Air Conditioner Clutch Continuously Engaged on M2 Plus Vehicles

TSB-54-363-FTL

Fig. 2, Changing the Parameter

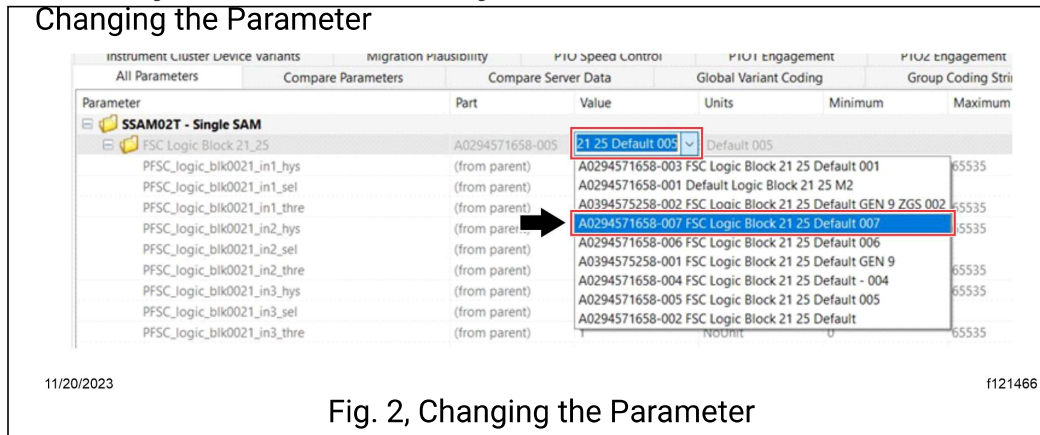
- In the list of parameters, locate 'FSC Logic Block 21_25.' Expand the drop-down menu in the 'Value' column and verify the parameter is set to A0294571658-007 FSC Logic Block 21 25 Default 007'. See Fig. 2.
